**SITE PLAN REVIEW SHEET
ENVIRONMENTAL VARIANCE REQUEST ONLY**

CASE: SP-2021-0021D

PROJECT NAME: 3800 Island Way

The applicant is requesting to vary from LDC 25-8-281(C)(2)(b) to allow construction of a boat dock within a 150-foot Critical Environmental Feature (CEF).

3800 ISLAND WAY
PROPOSED CONDITIONS SITE PLAN

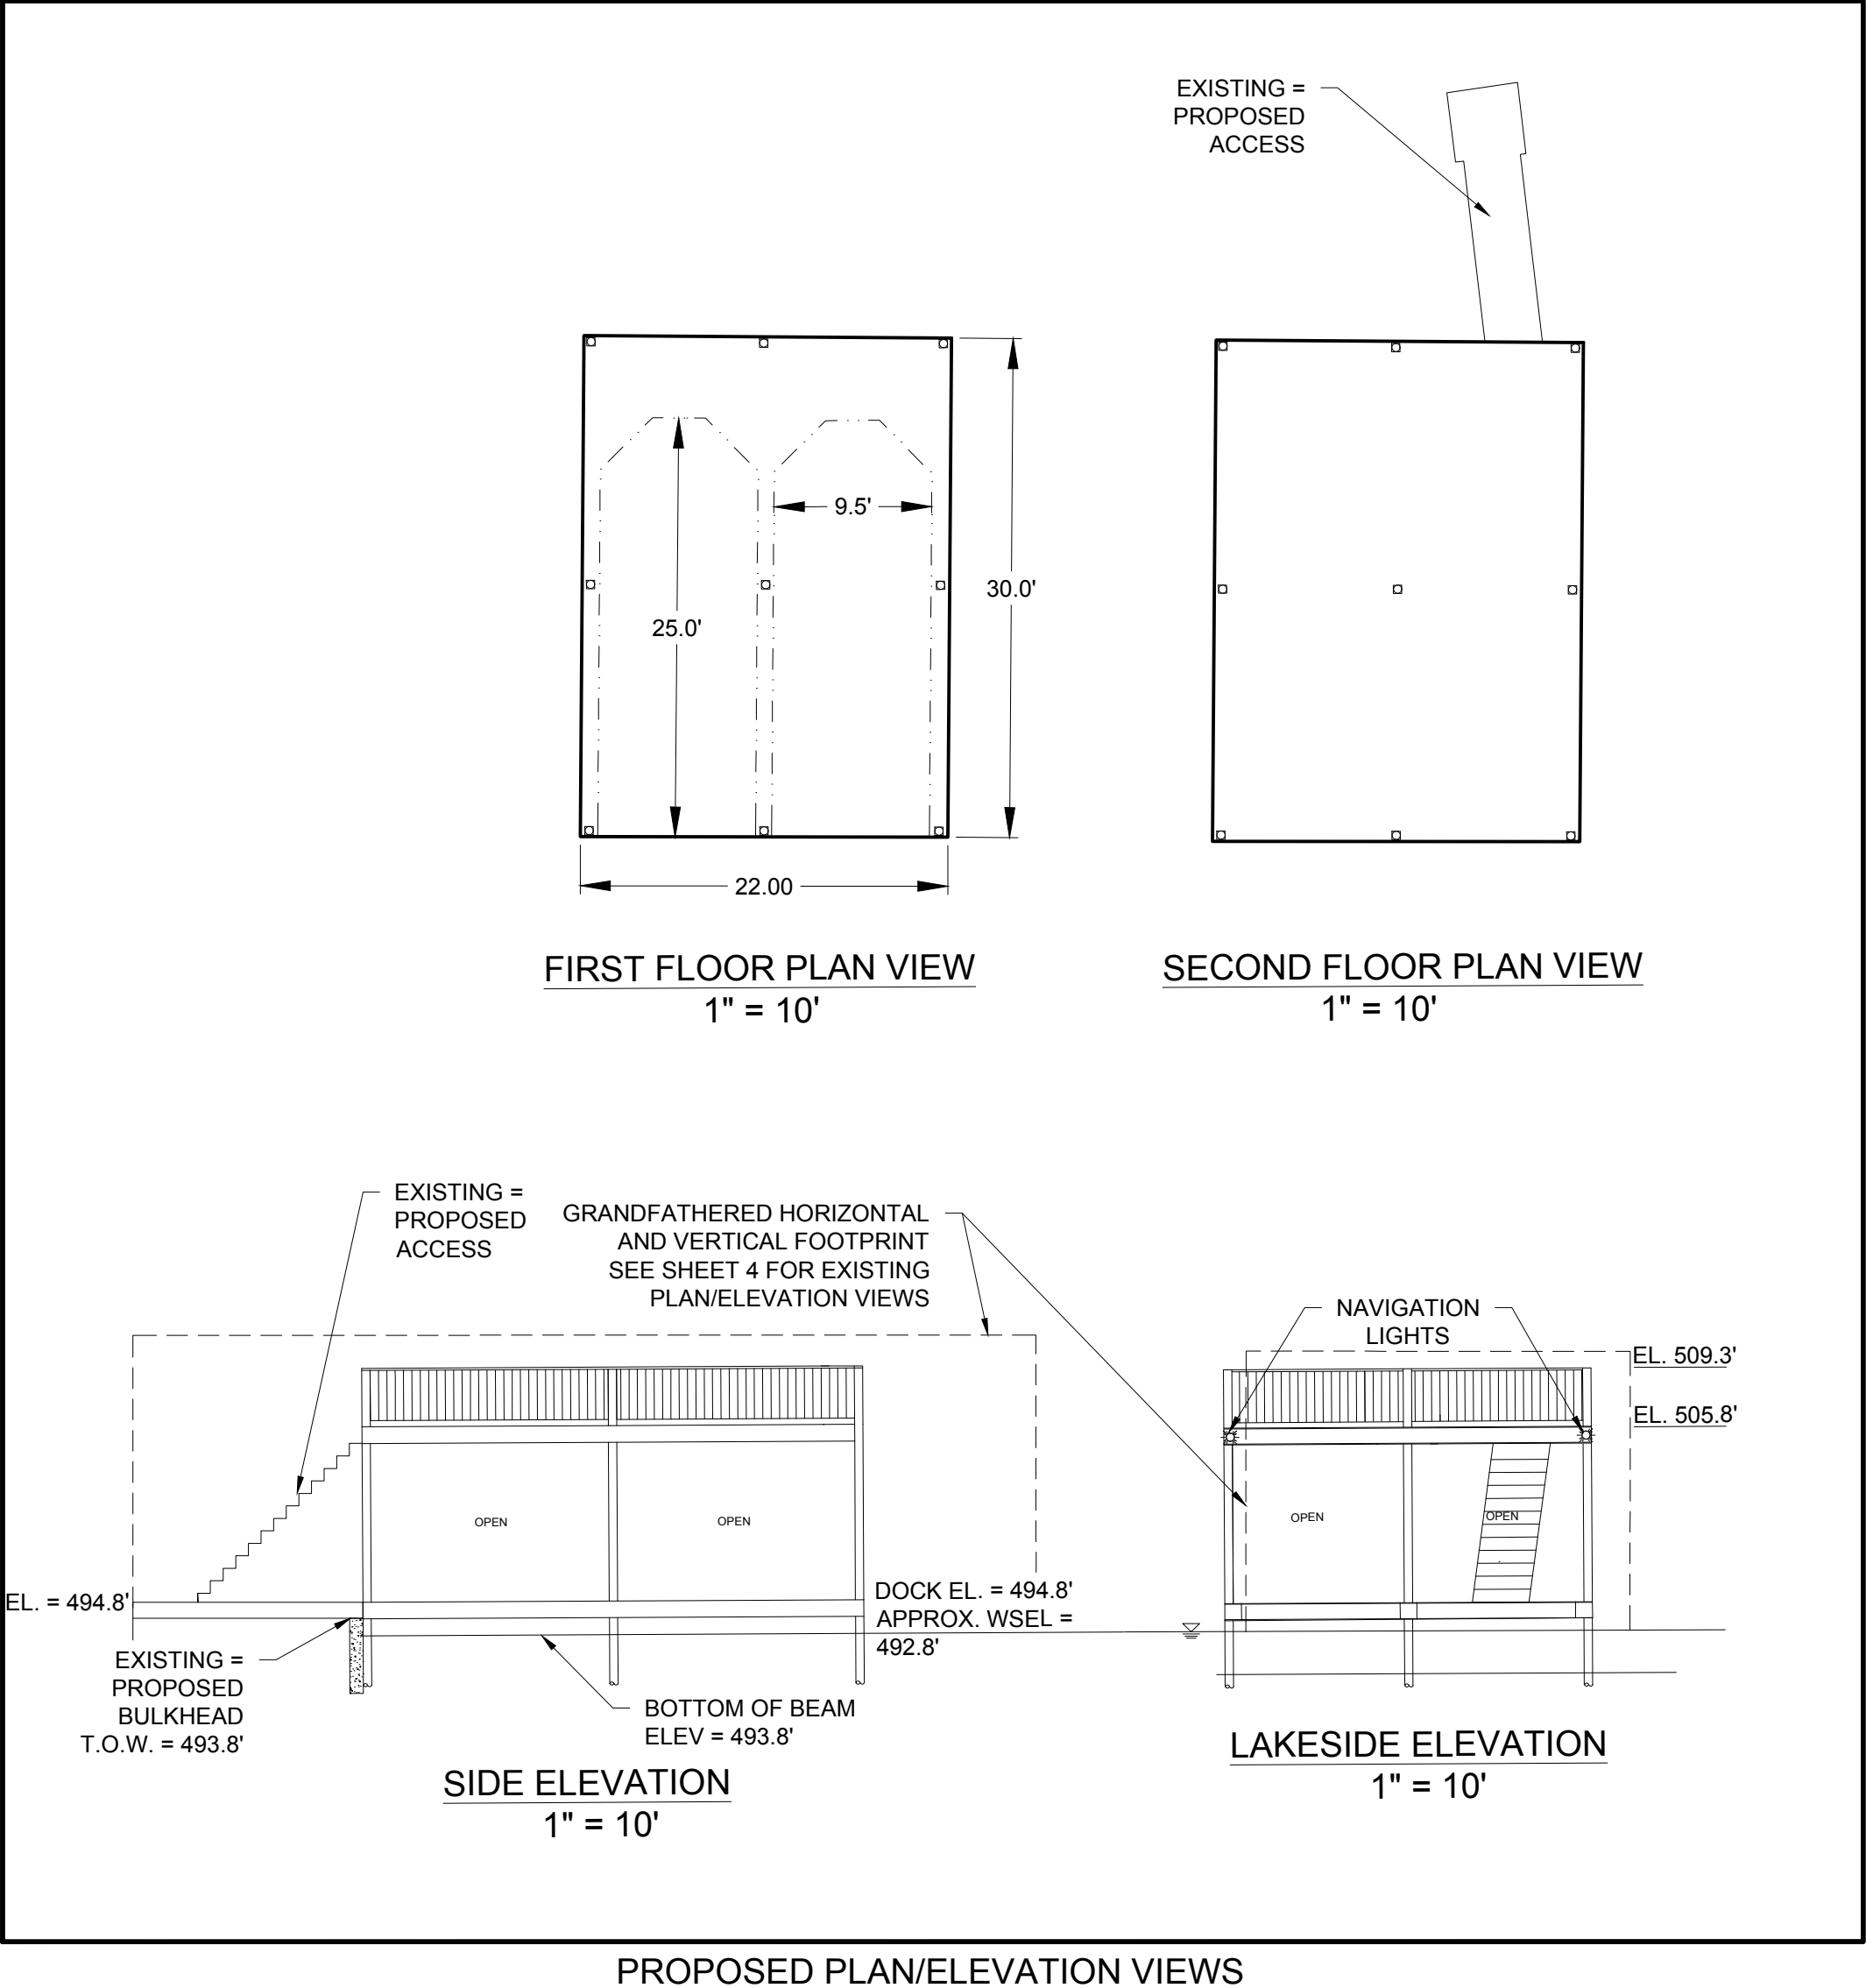
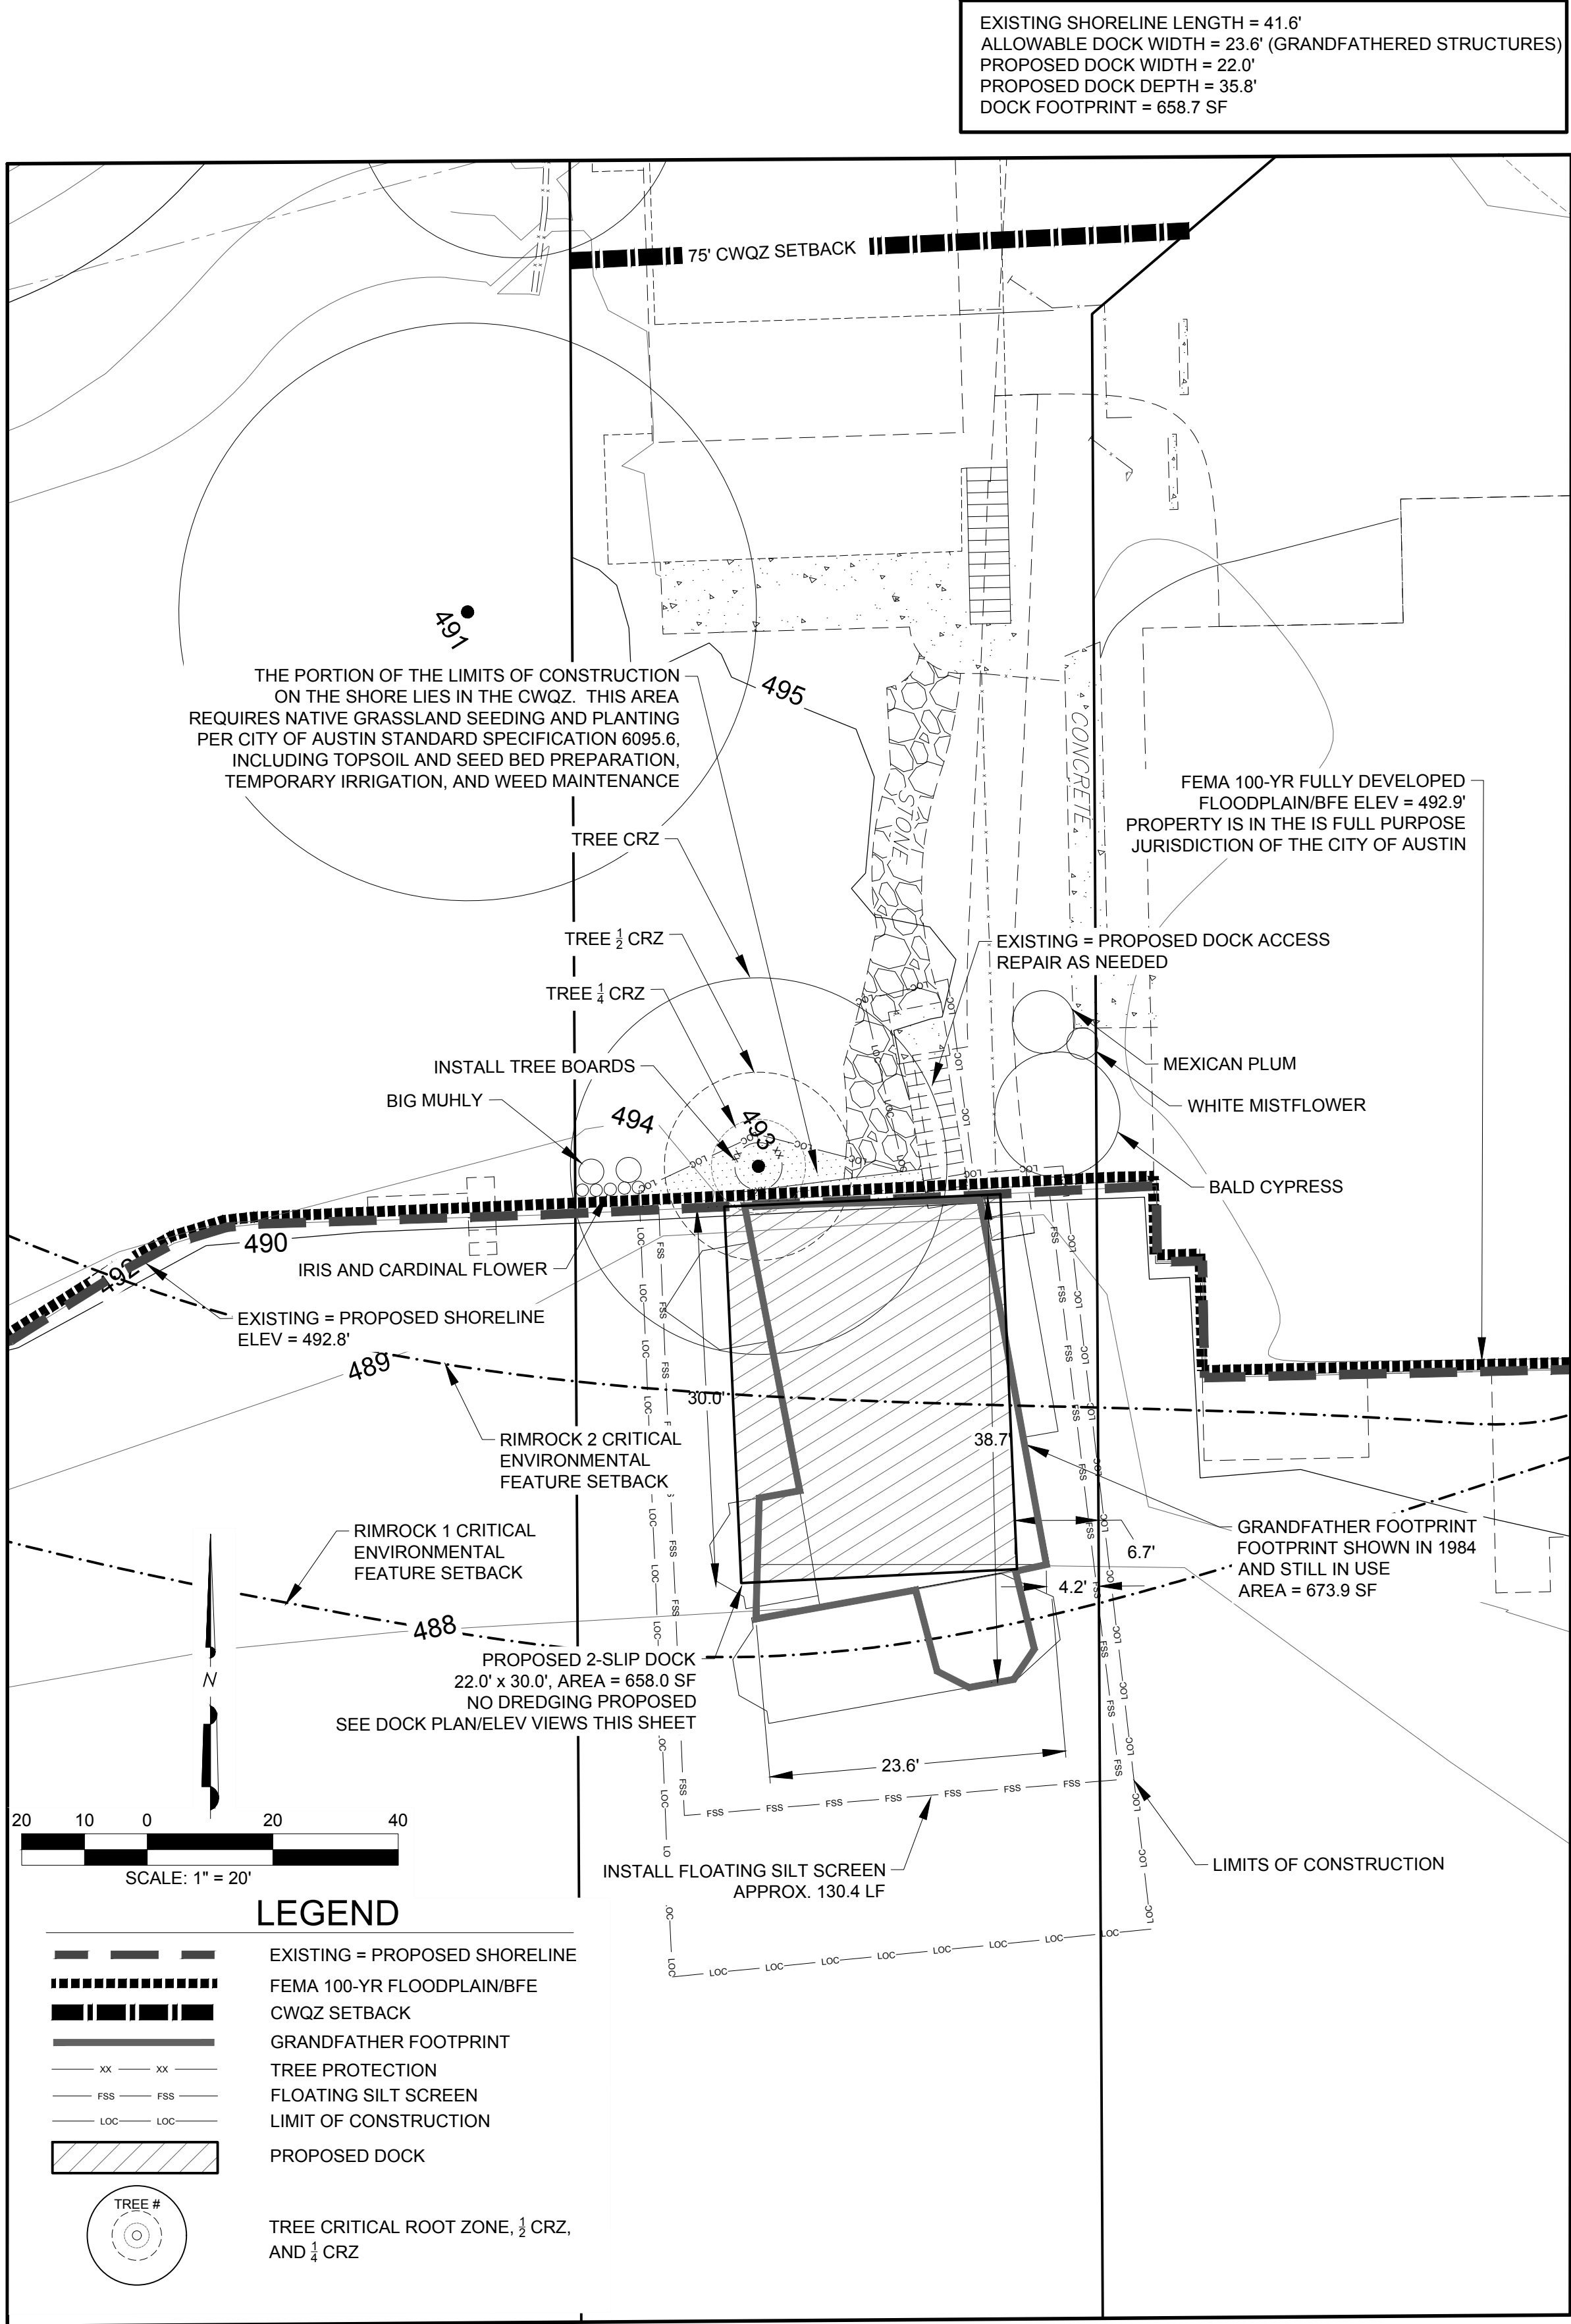
Yes. No disturbance of the rimrock CEF is proposed, all proposed construction activities are to occur downgradient of the rimrock CEFs, and construction is to occur from the lakeside by barge. The proposed construction to be performed from a barge provides greater overall environmental protection. Additionally, the applicant is providing wetland plantings that will reduce shoreline erosion and sediment-laden surface runoff from discharging into the lake.

Yes. The variance does not create significant harmful environmental consequences. The construction of the boat dock from barge will not disturb the rimrock critical environmental feature. The applicant is providing wetland plantings that will reduce erosion and sediment-laden surface runoff from discharging into the lake.

The findings of fact have been met, and staff recommends approval for construction within a 150 foot Critical Environmental Feature (CEF) with the following conditions:

- 1) All construction activities to be completed by barge.
